ADDENDUM NO. 2

Issue Date:	January 17, 2024
Project Name:	Sandridge Golf Club New Clubhouse
ITB Number:	2024029
ITB Opening Date:	**February 1, 2024**

This addendum is being released to provide answers to questions received to date, modify the bid documents, provide additional background documents, and provide minutes to the pre-bid meeting.

A 605

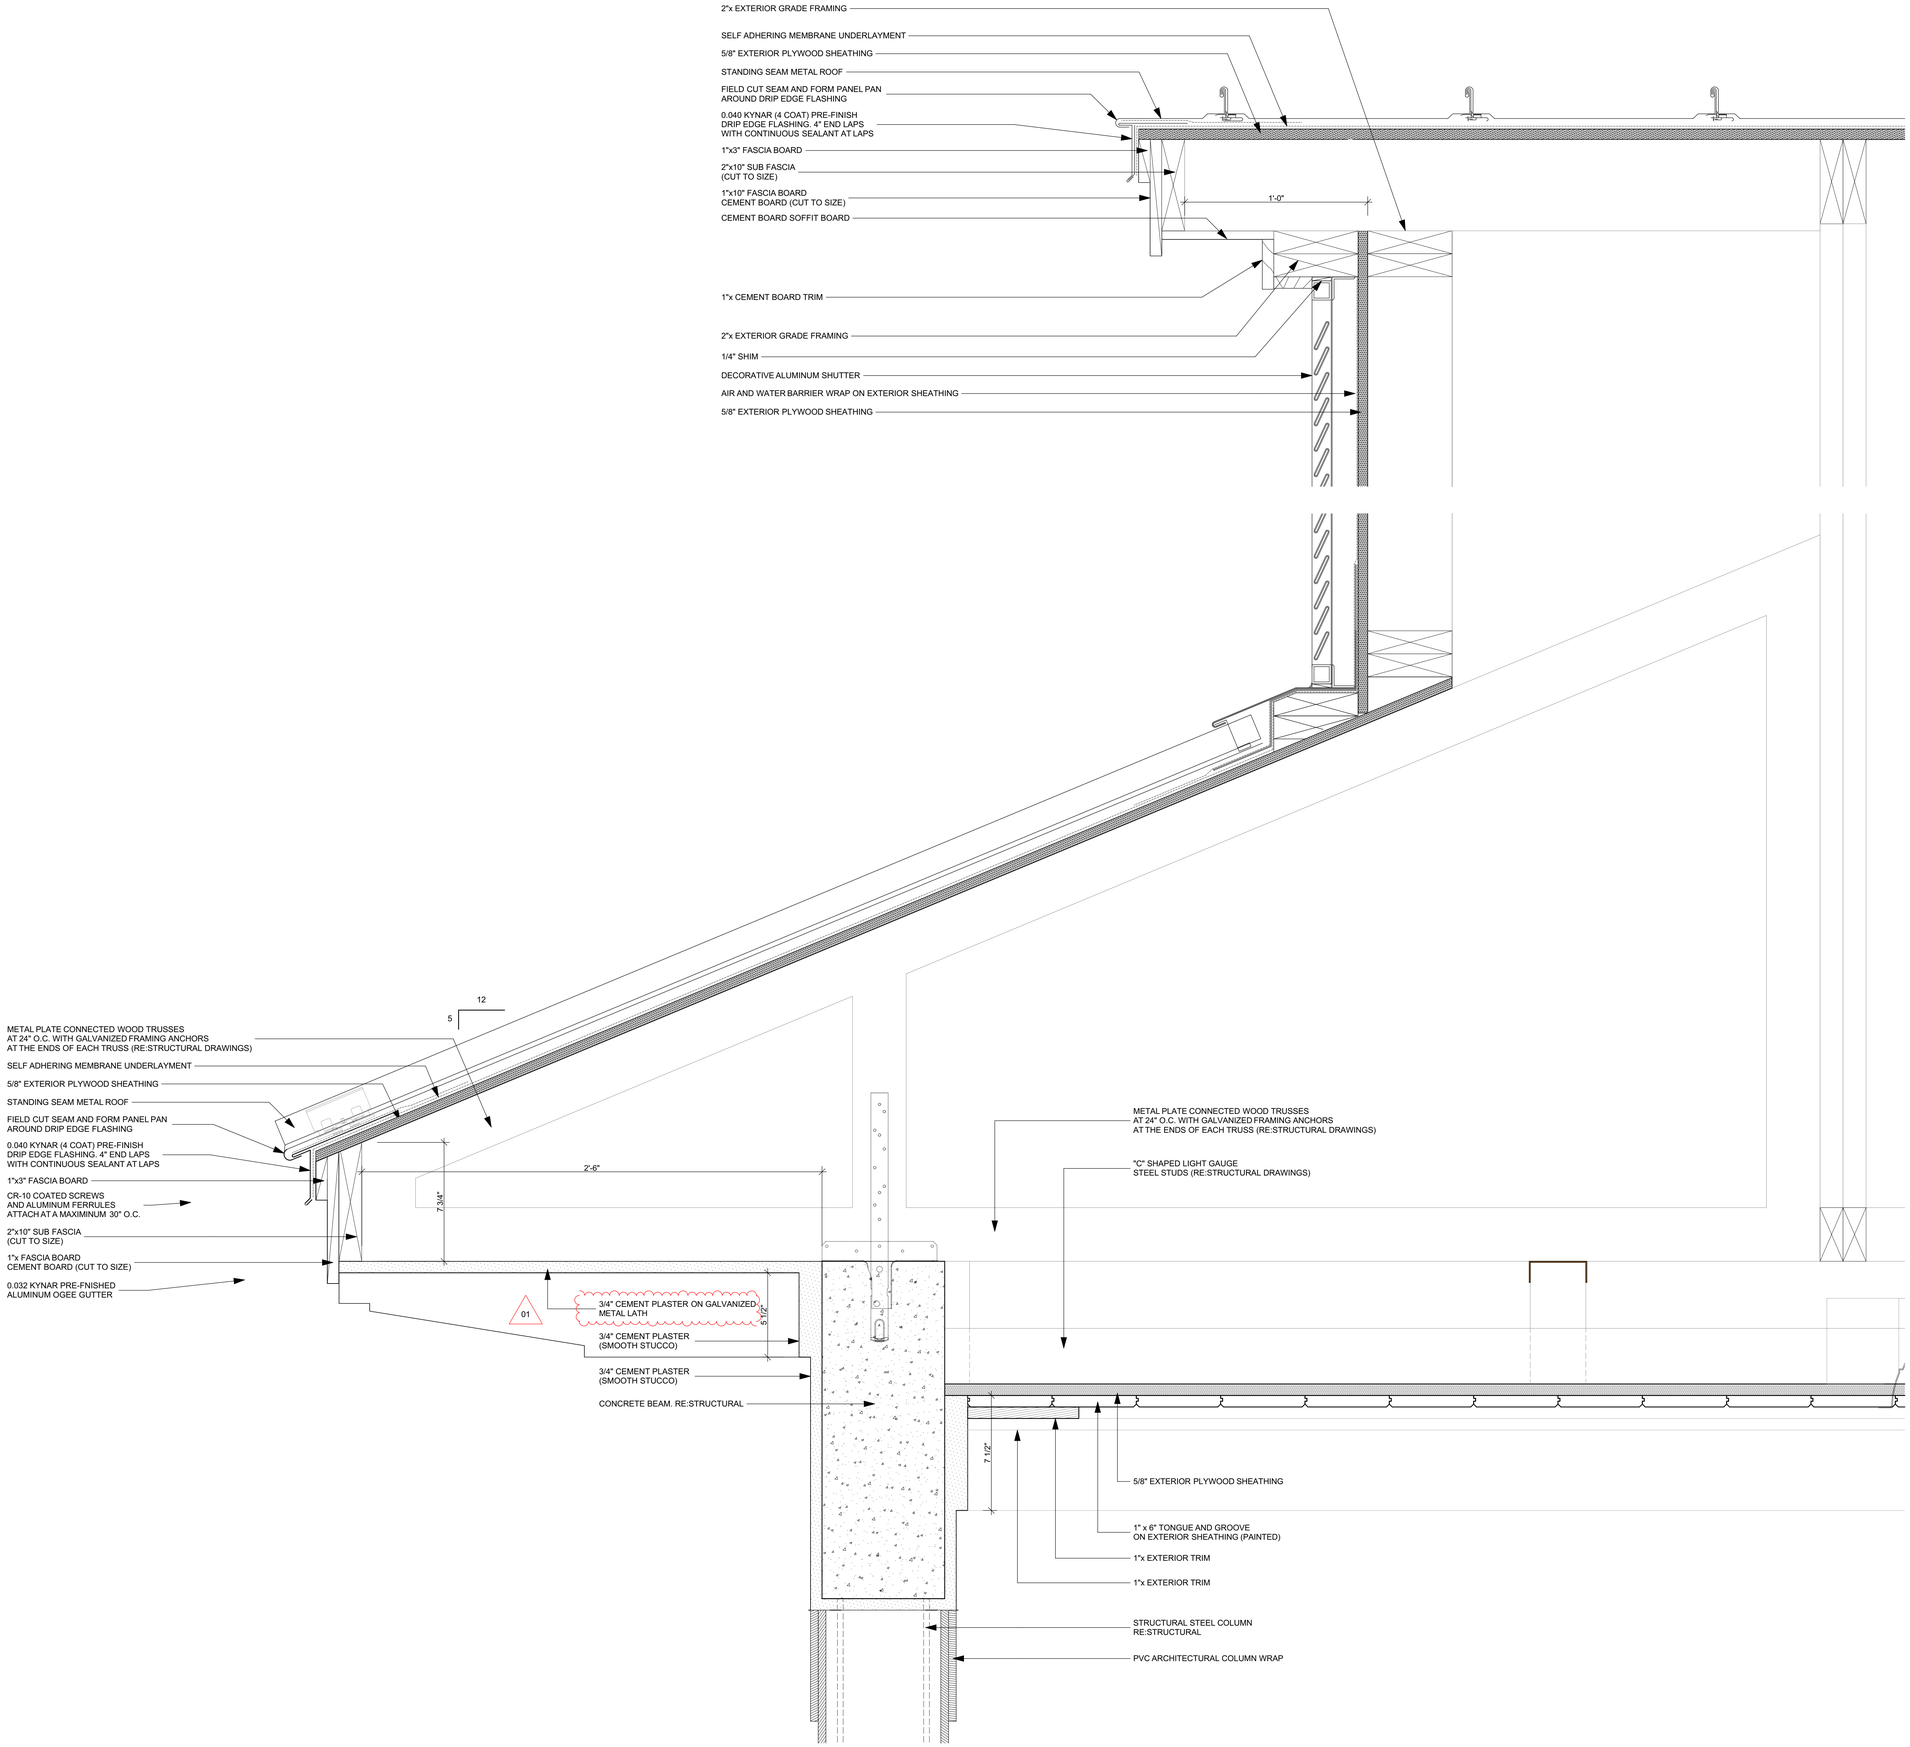
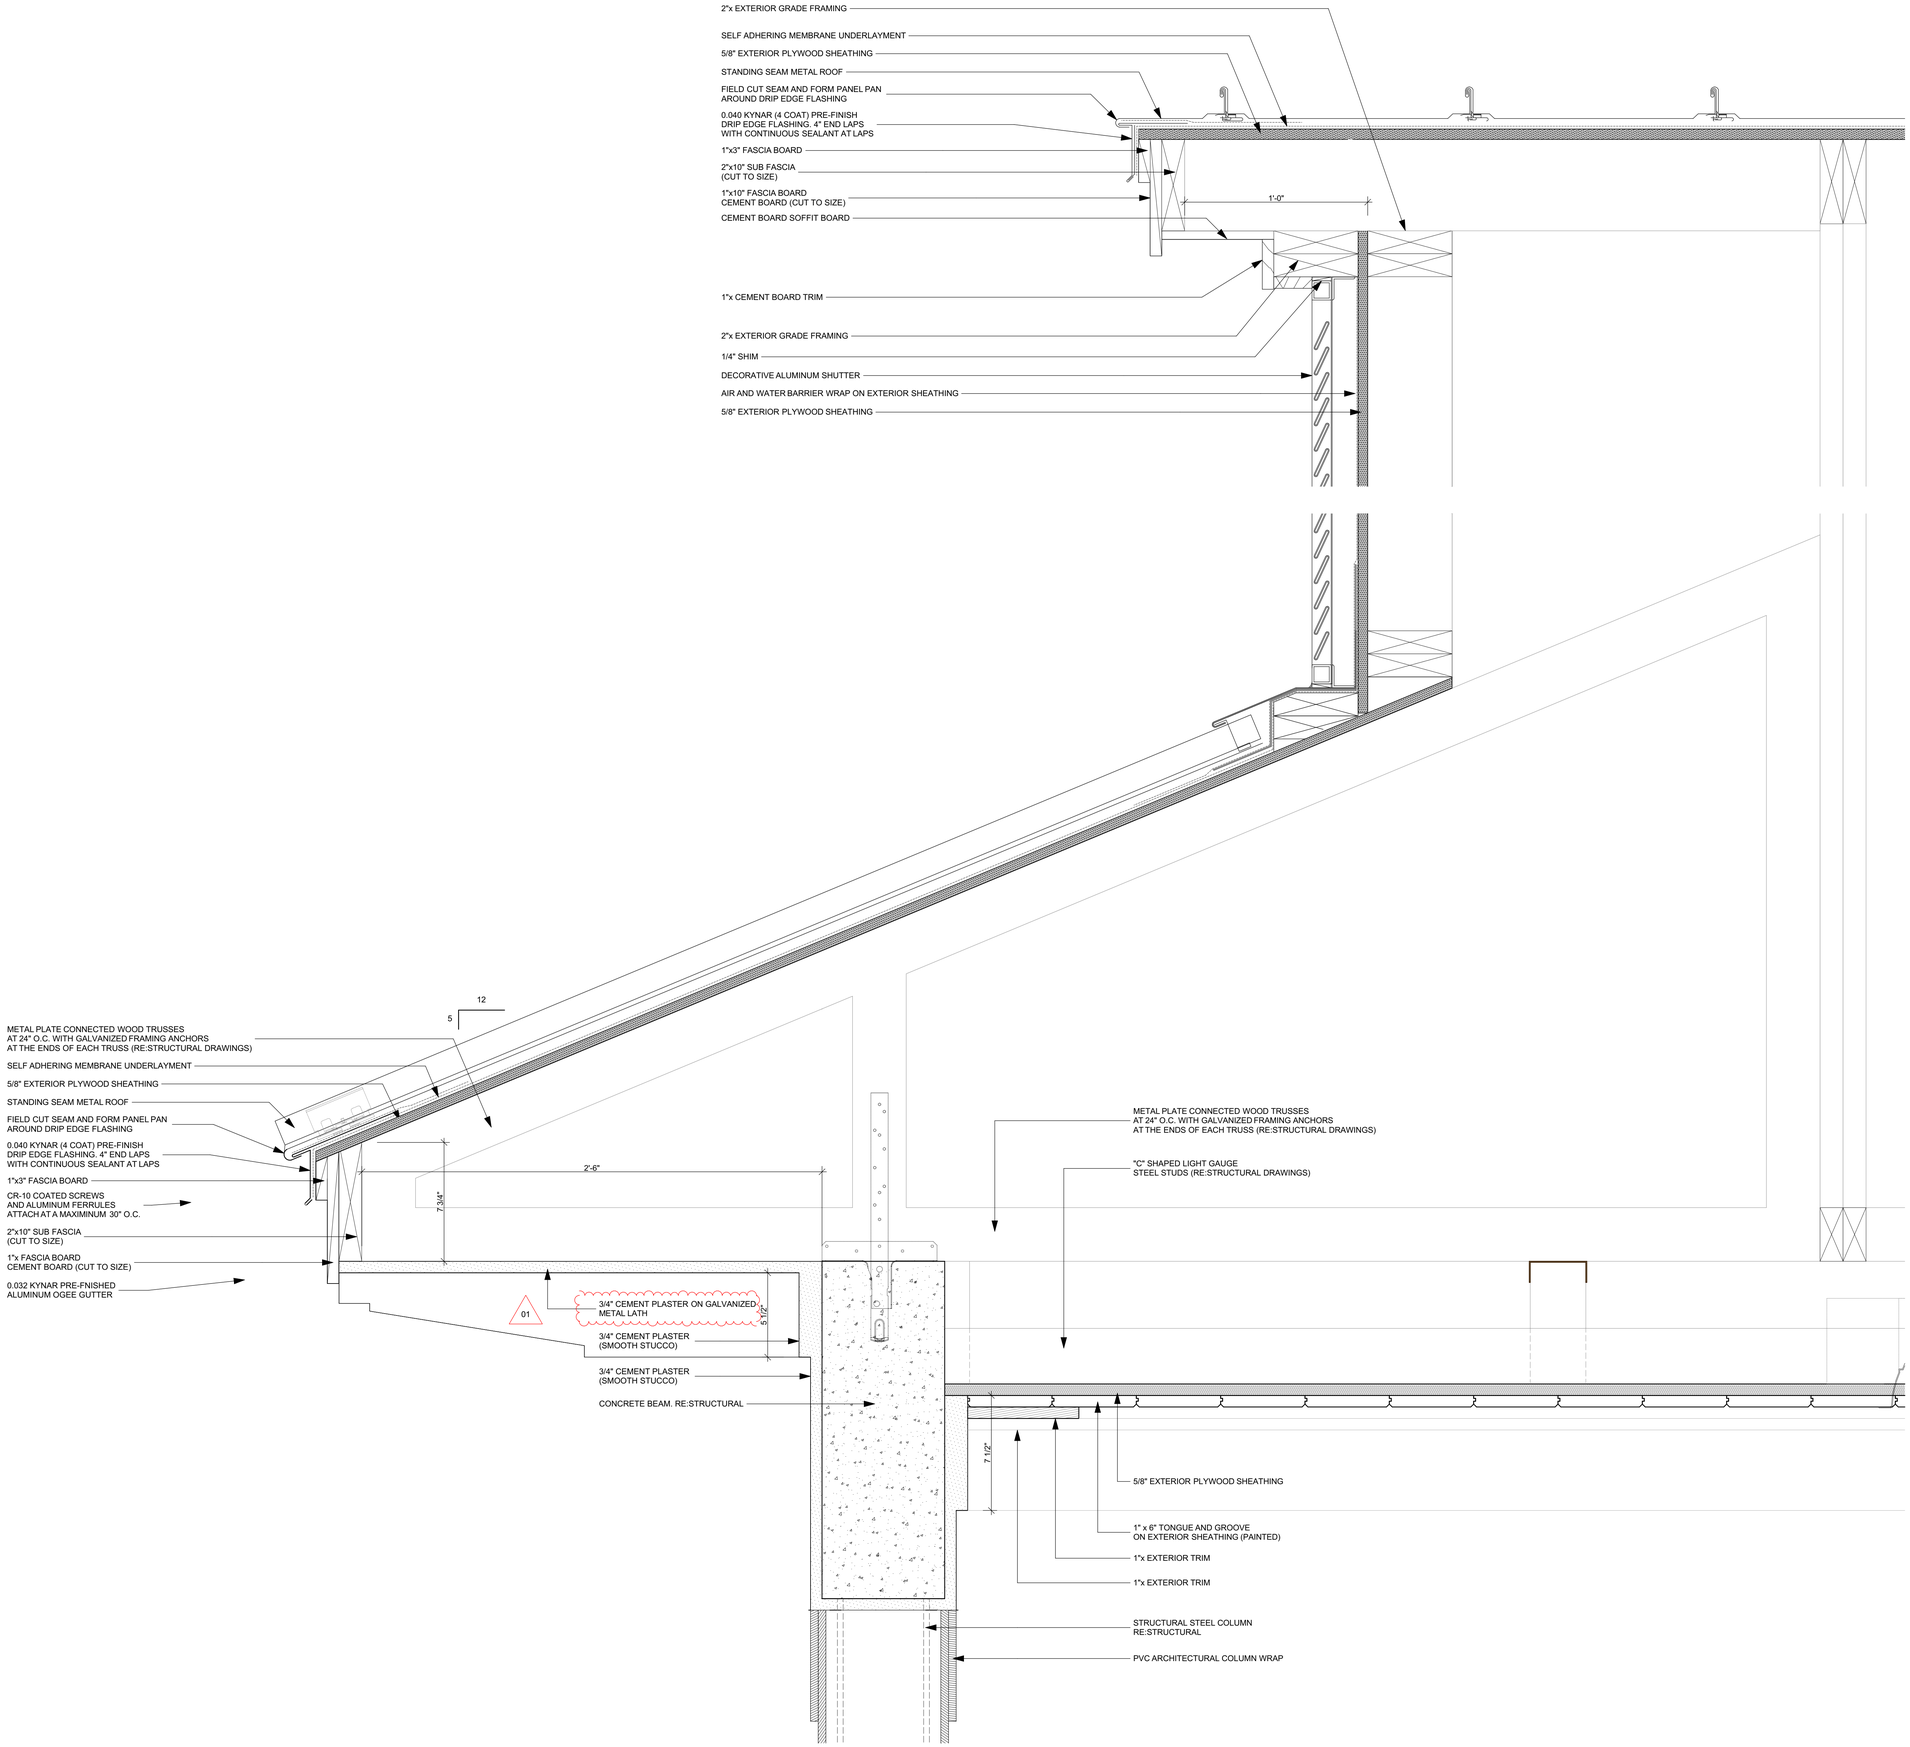
6. SOFFIT OVERHANGS FOR THE BUILDING HAVE 2 DETAILS (1) SMOOTH STUCCO W GALVLATH., (2) HADY CEMENT BOARD. PLEASE CLARIFY THE CORRECT DETAIL
The typical soffit for the clubhouse and turn building is smooth stucco w/galv. Lath. Cement board soffits occur at roof dormers only. See revised sheet A705 for clarification.
